VILLAGE STAFF REPORT OF JULY 13, 2015

The petitioner is requesting several approvals for the development of the 2.01 acre site located at the southeast corner of STH 50 and 94th Avenue (Outlot 21 of Prairie Ridge Subdivision) based on the Conceptual Plan that was conditionally approved by the Village Board on June 1, 2015 for the development of two (2) retail/restaurant buildings on the property generally located at the southeast corner of STH 50 (75th Street) and 94th Avenue within the Prairie Ridge development. The approvals being considered by the Plan Commission at this meeting include a Certified Survey Map, a Zoning Text Amendment and Preliminary Site and Operational Plans.

TO: Jean Werbie-Harris, Community Development Director
FROM: Doug McElmury, Chief Fire & Rescue Department
CC: Deputy Chief, Craig Roepke
Lt. Thomas Clark, Fire & Rescue Department
Peggy Herrick, Assistant Planner, Community Development
SUBJECT: Review of the Preliminary Site and Operational Plan for Out lot 21, Multi-tenant Retail
DATE: 10 July 2015

Design Development Plans

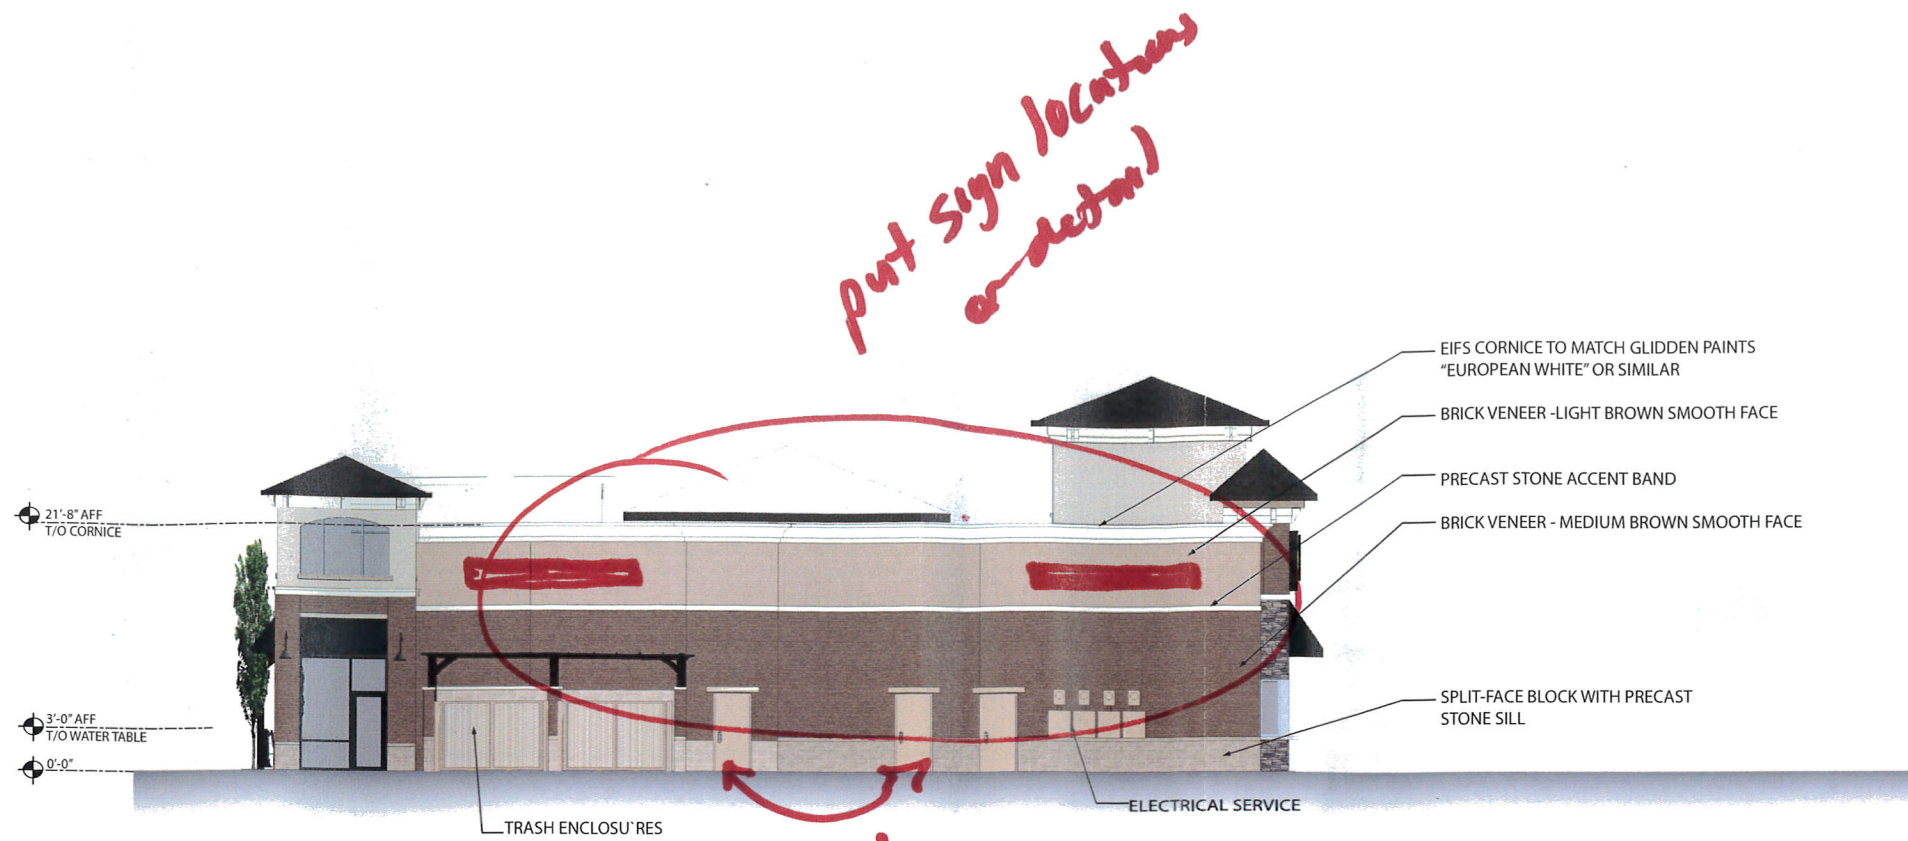
Need color/paint materials

2015.0011.01
SHEET
C-3

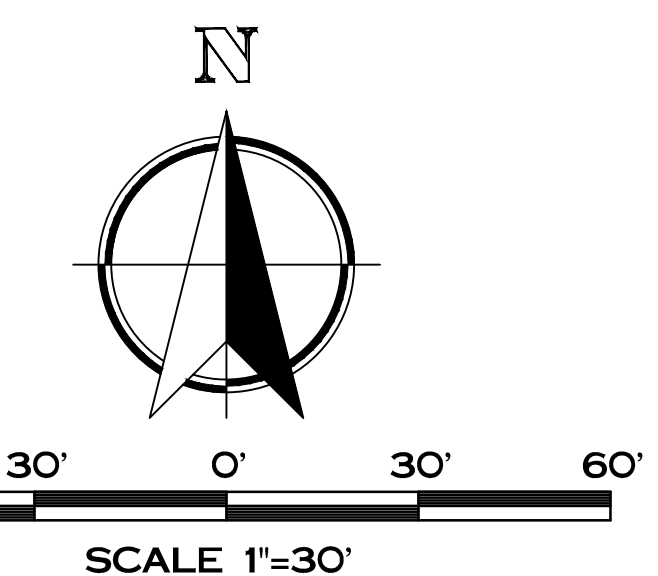
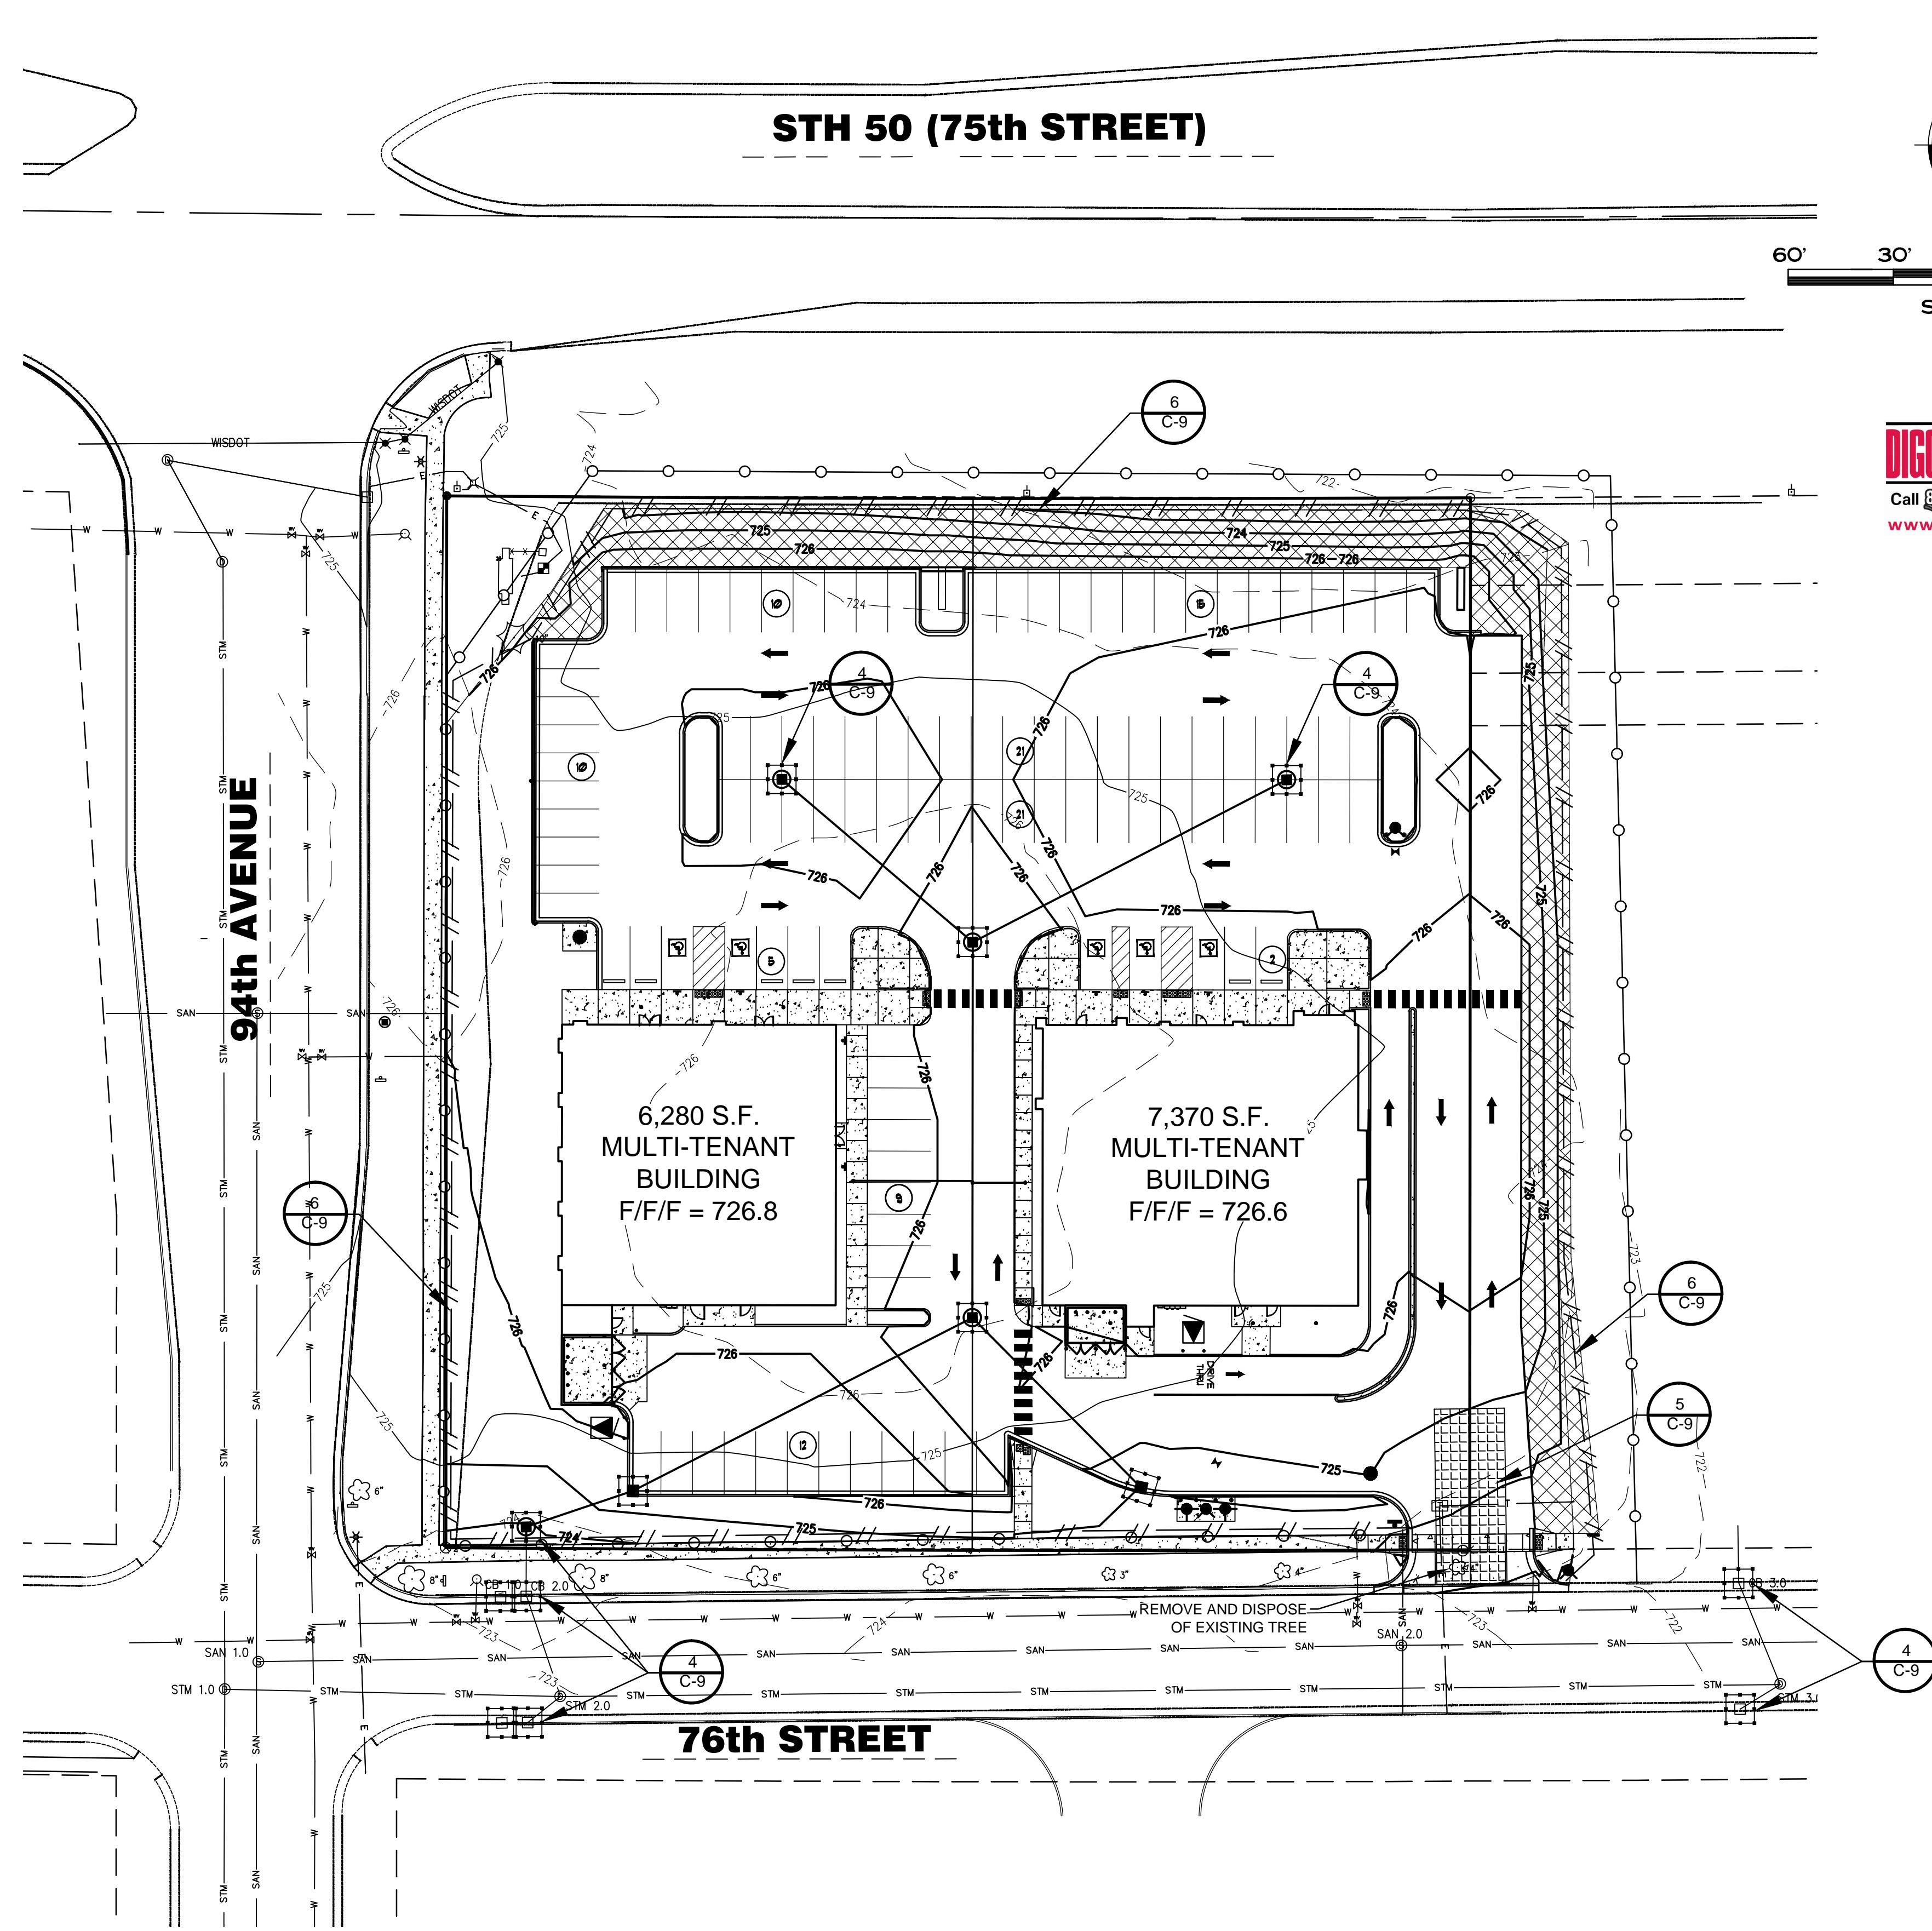
- f. On Sheet C-3:
 - i. Clearly label and delineate all existing Rights-of-Way (75th and 76th Streets and 94th Avenue).
 - ii. The curbed island for the restaurant drive-thru lane shall be extended to the north to a line across from the patio seating area. (Revise all plan sheets).

- iii. No curb or wheel stops will be allowed - raised sidewalks shall be used for car bumpers at the front of the stores/restaurants. Revised all plan sheets.

- iv. The site plan legend indicates a symbol for a Light Pole; however there are no light poles shown. All light poles shall be in a landscape islands within a maximum of 18 inches concrete bases. The same LED light pole (style and color) for all development in Outlots 20 and 21 will be required. The height of all light poles and bases shall be 20 feet.

- v. Show details of the ornamental black bollards around outdoor dining areas.
 - vi. Show the required bollards around the electrical transformers. All bollards around the transformers and garbage dumpsters shall be painted black.

- vii. There is a sign shown along the western most parking area on midway along the parking spaces. What is this sign? Compact car parking?
 - viii. Provide a detailed on-site informational, directional, traffic and other site signage plan showing locations, heights, areas, sizes, and lighting.

- ix. Is a sign being installed at the drive-thru? Show location on the plans.
 - x. Show the setback distances from the primary monument signs to the property lines and the back of curb.

- xi. Show the setback distances from the building to the side property lines (common side property line).
 - xii. On the site data information change "Parcel ID Number" to "Tax Parcel Number".

PROJ. MGR: _____ MDE
DRAFTED: _____ JJC
DATE: 4-6-2015
CHECKED: _____ MDE
DATE: 6-12-2015
2015.0011.01
SHEET
C-10

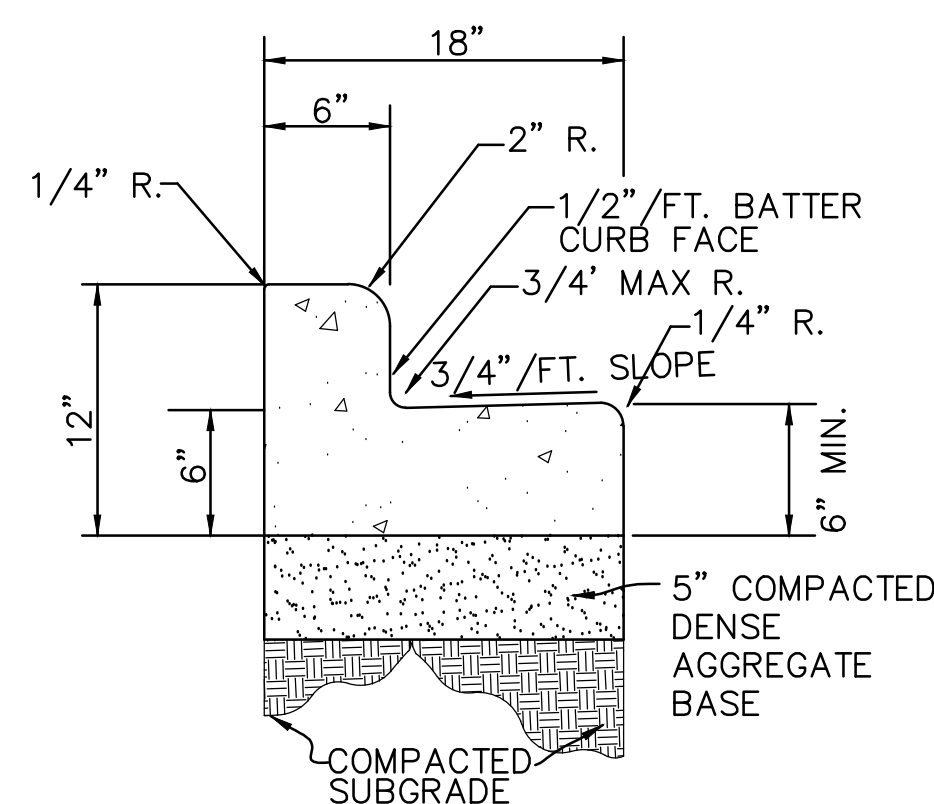
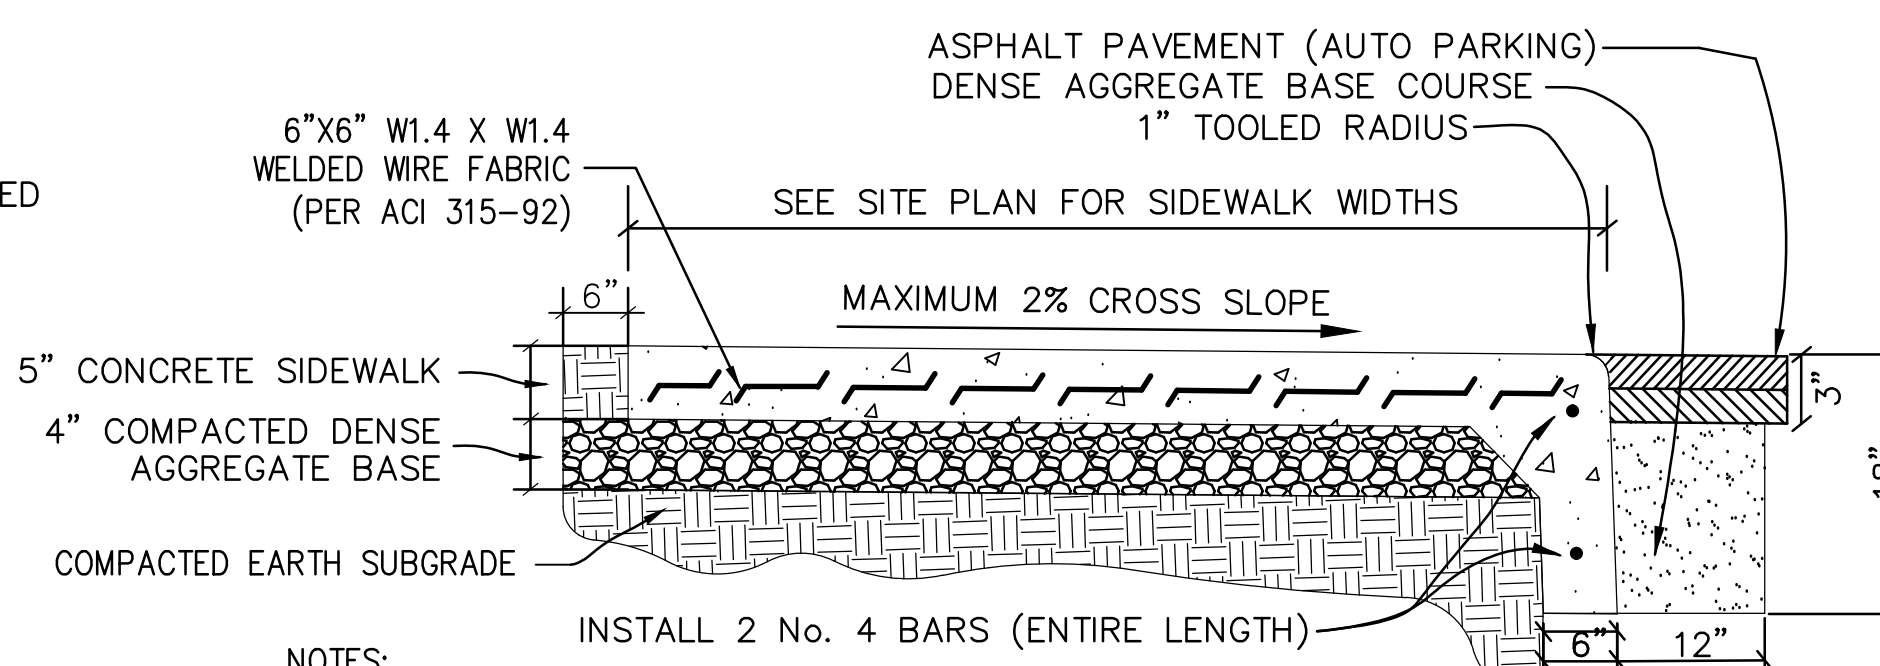
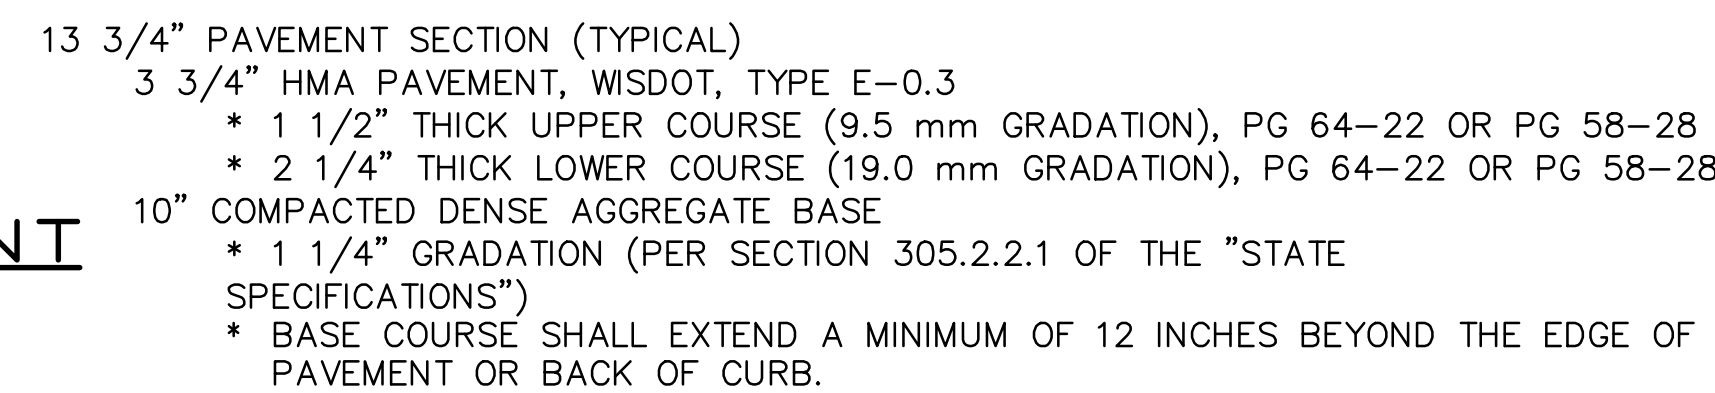
- l. On the Typical Sections and Construction Details (Sheet C-10): The base thicknesses specified for both the trash enclosure and sidewalk does not match the details.
